Lafayette Townhouse Cooperative

July 2, 2025

Detroit Historic District Commission
Planning and Development Department
Coleman A. Young Municipal Center
2 Woodward Avenue, Suite 808
Detroit, MI 48226

Re: Detroit Thermal proposed construction project at Mies Coops

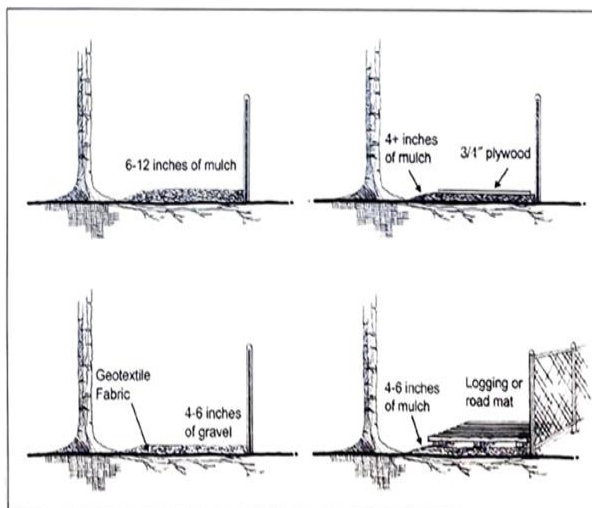
For soil protection he suggests "commercial grade plywood" or steel plating. Note: commercial grade plywood typically means it is water resistant. It is unclear what thickness Detroit Thermal intends to use for

the plywood. Likewise, without listing specific products it is difficult to say steel plating is sufficient. As shown in figure above from the BMP, 4" to 12" of wood mulch under at least ¾" plywood or road mats is required for effective soil protection. Detroit Thermal's plan notes overlapping plywood, no specified thickness and no mulch, and only for the access road.

TREE MAP: DT CONSTRUCTION ZONE 1 (Mies Greenspace, Garden, Playground)

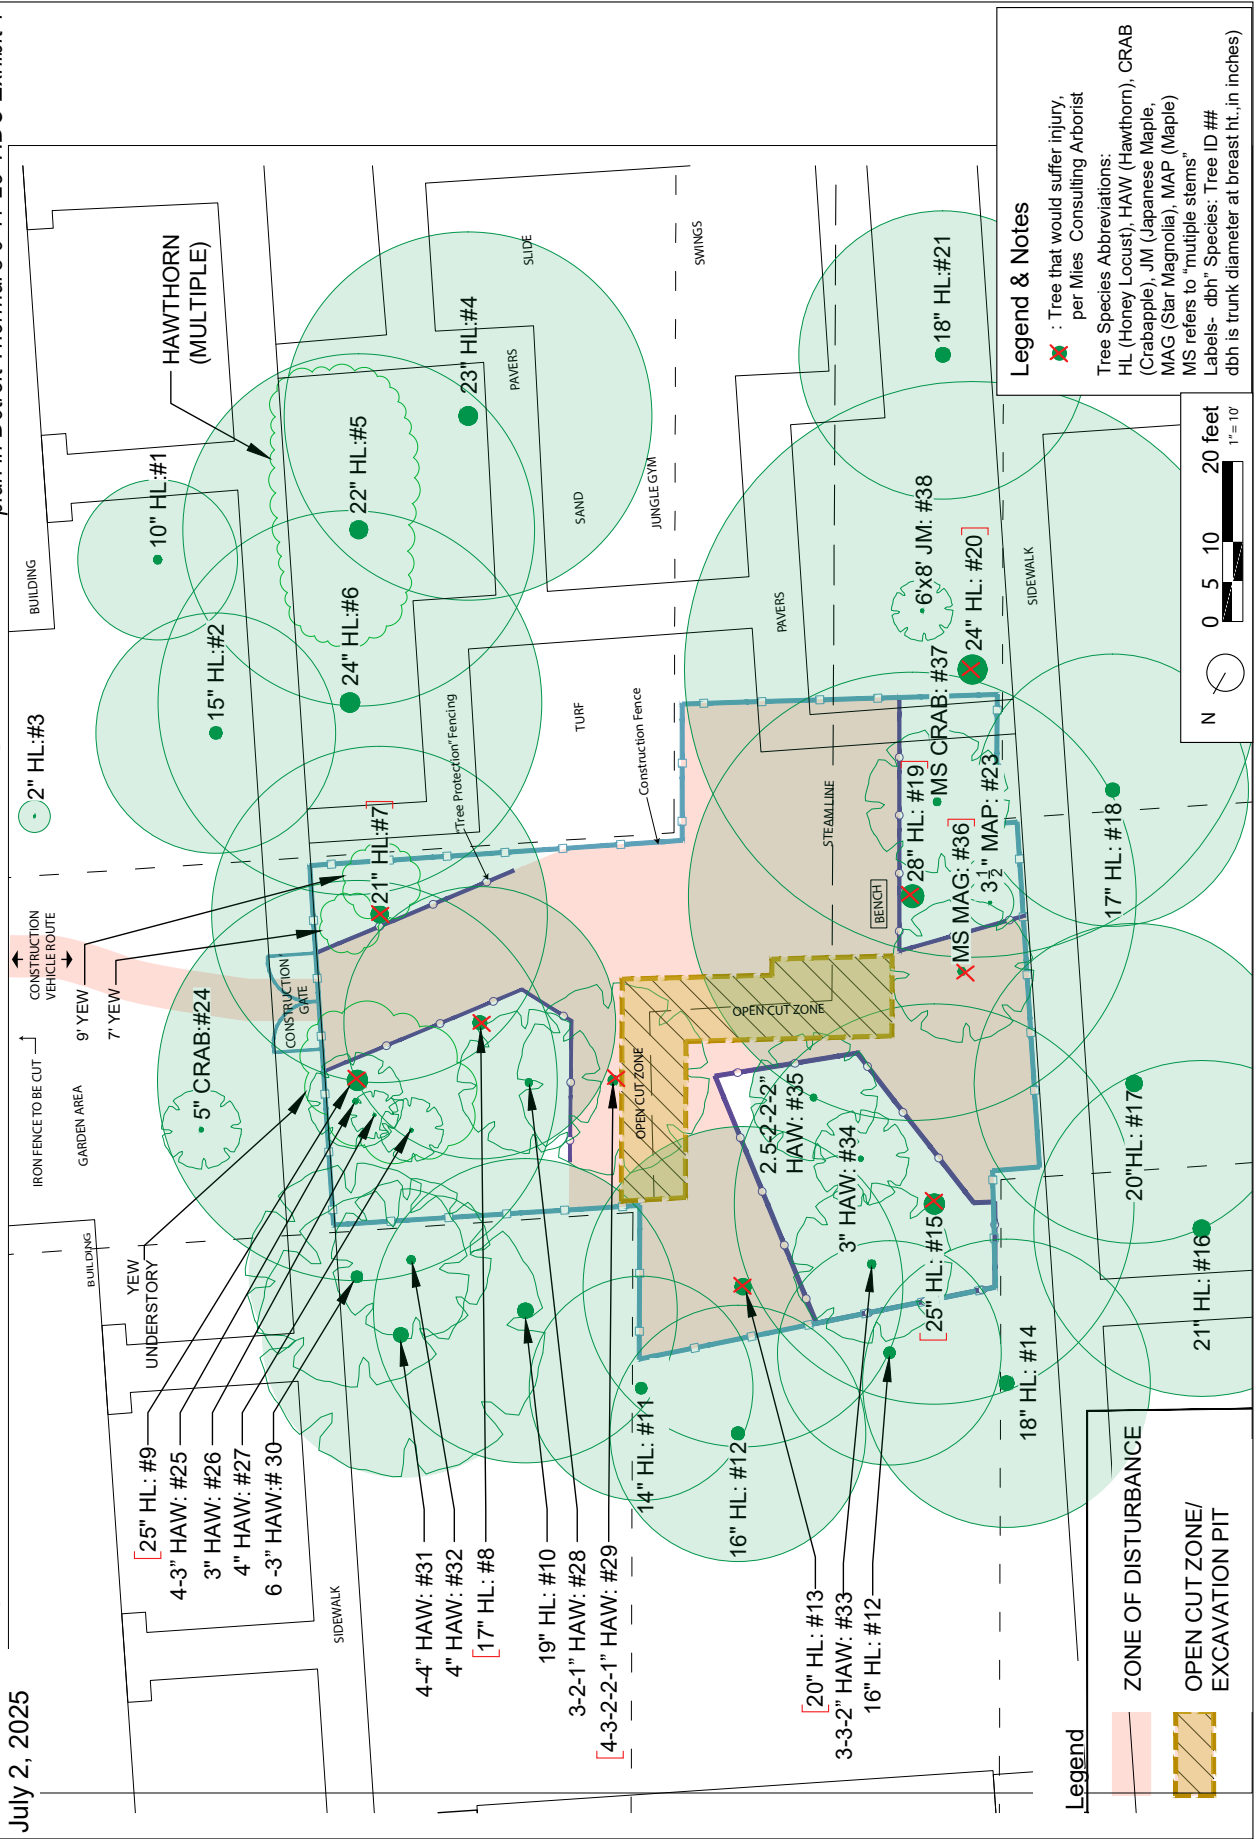
In Zone 1 there are nine trees of concern. The top six trees listed are expected to suffer severe construction injury based on the proposed construction plans:

- 21" honeylocust – Tree # 7.
- 17" honeylocust – Tree # 8.
- 25" honeylocust – Tree # 9.
- 20" honeylocust – Tree # 13.
- 28" honeylocust – Tree # 19.
- 7" (four stem) hawthorn – Tree # 29.
- 25" honeylocust – Tree # 15.
- 24" honeylocust – Tree # 20.
- 3" (4 stem) star magnolia - Tree # 36.
 - Note: this tree has already had half of its stems broken by Detroit Thermal with its earlier site work.

Southern Mies, N of E. Lafayette Ave.

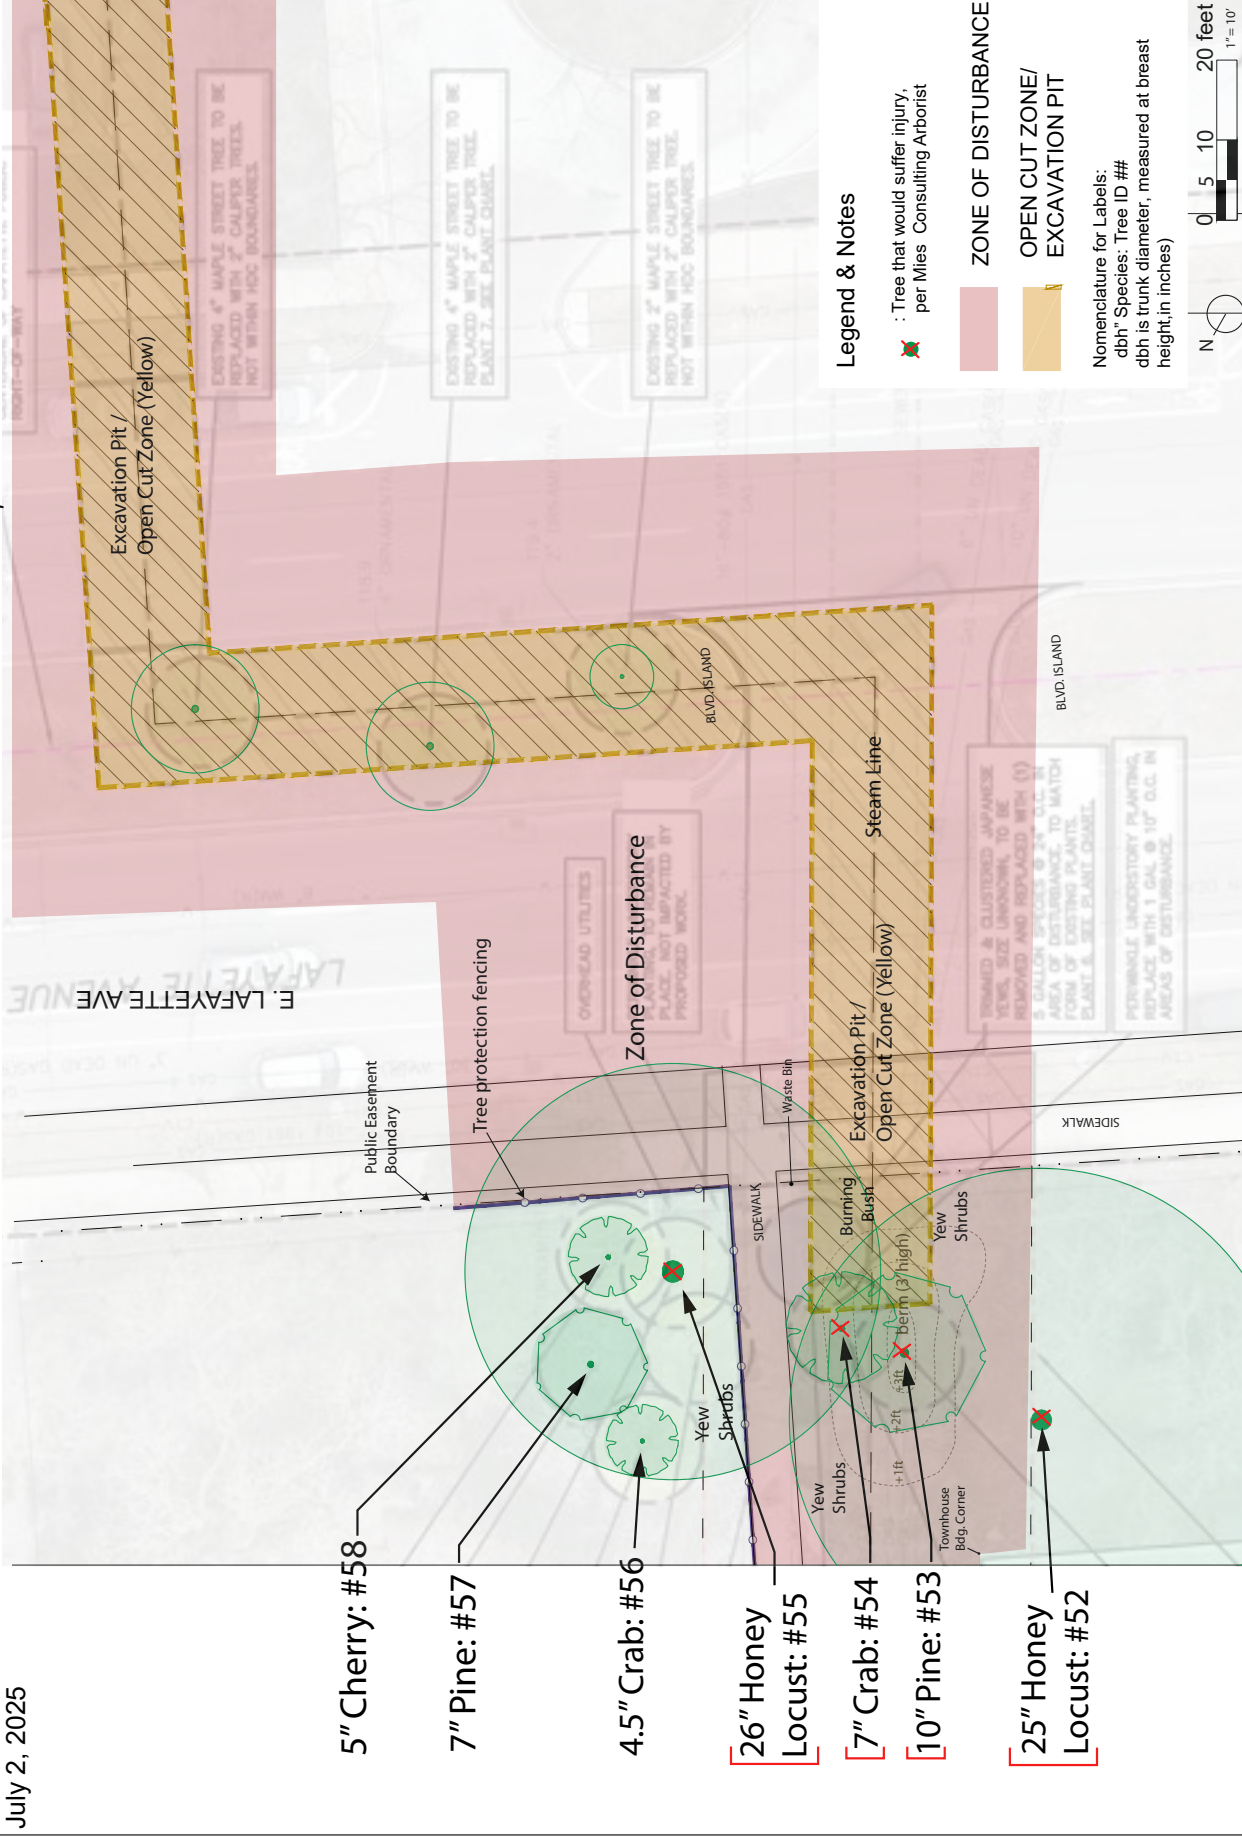
There is little detail in Detroit Thermal's plans regarding how and where they will stage machinery to excavate and remove/store spoils in this zone. That said, the crabapple #54 and Austrian pine #10 discussed above will suffer serious impacts. In addition, the two large honeylocust trees in this area could suffer root injury by the open cut zone and compaction.

- 25" honeylocust – Tree #52
 - Note: Detroit Thermal's plans omit this tree.
- 26" honeylocust – Tree #55
 - Note: Detroit Thermal's plans state no impact for this tree.

ROUGH REDLINE OF DT'S PLANS, SHOWING MANY ERRORS IN TREE SURVEY

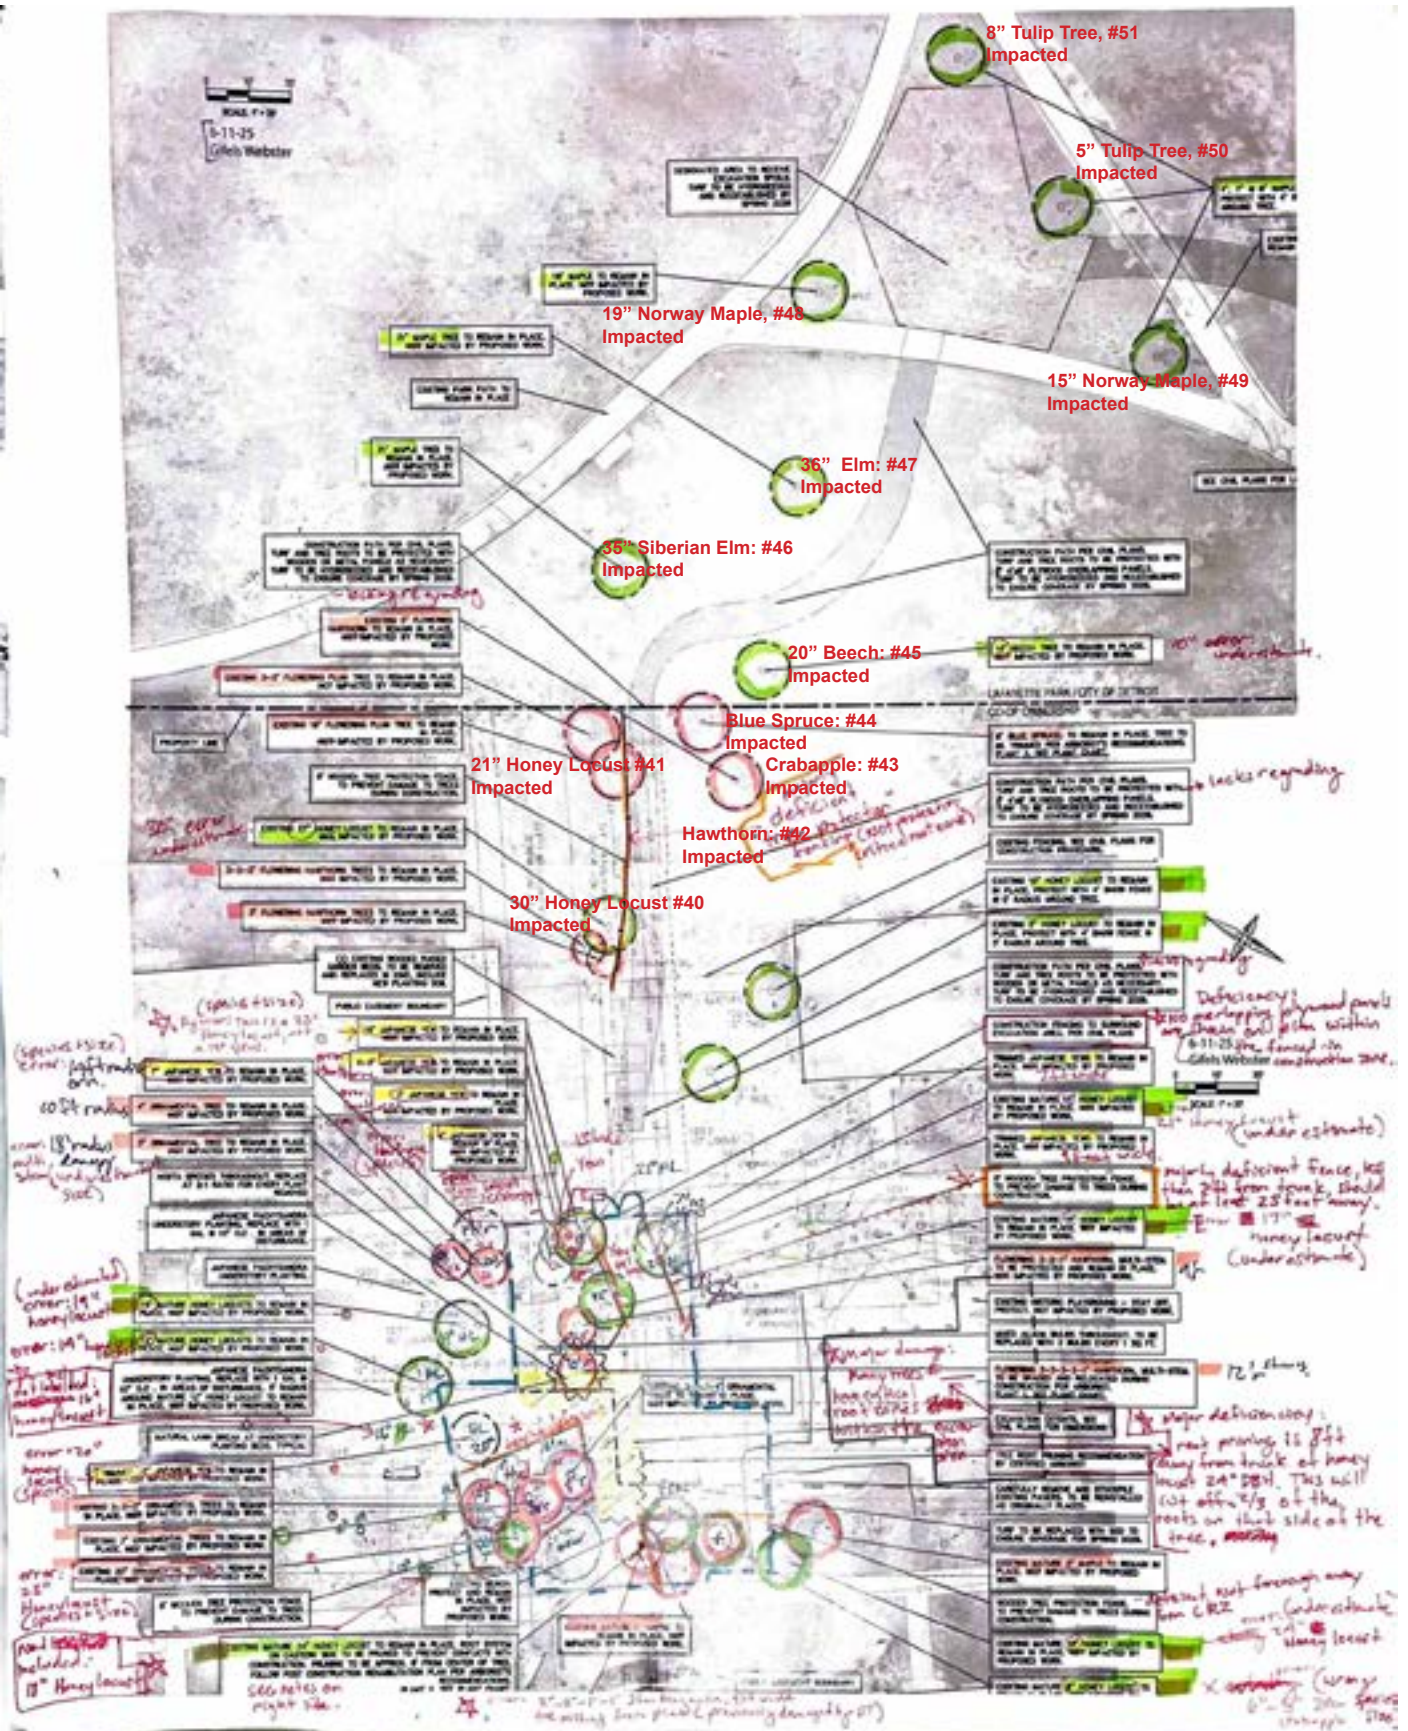
The June 11th plans, while containing more information, still lack sufficient tree protection measures. Additionally, there are many errors such as misidentified trees and shrubs, missing trees and incorrect trunk diameter upon which tree protection is determined. These errors are identified in the rough red-line of Detroit Thermal's landscape enlargement at the end of this report. We have found at least 18 instances where Detroit Thermal's plans underestimated trunk diameter at breast height according to my measurements. There are 14 errors with incorrect species labeled. The most common errors are mature honeylocust trees being labeled as yew shrubs.

Provided in Landscape Enlargement "A", that has a number of errors including a missing tree, misidentification of trees, and no tree protection zone/critical root zone identified. For instance, a 25" honeylocust, #15 on the communities' map, is called an ornamental tree with no impact by proposed work. This 25" dbh honeylocust tree's critical root zone is well within the work zone.

1. Prior to any construction, Detroit Thermal must redo the construction plan to show all trees in the construction area, with correct species and sizes.
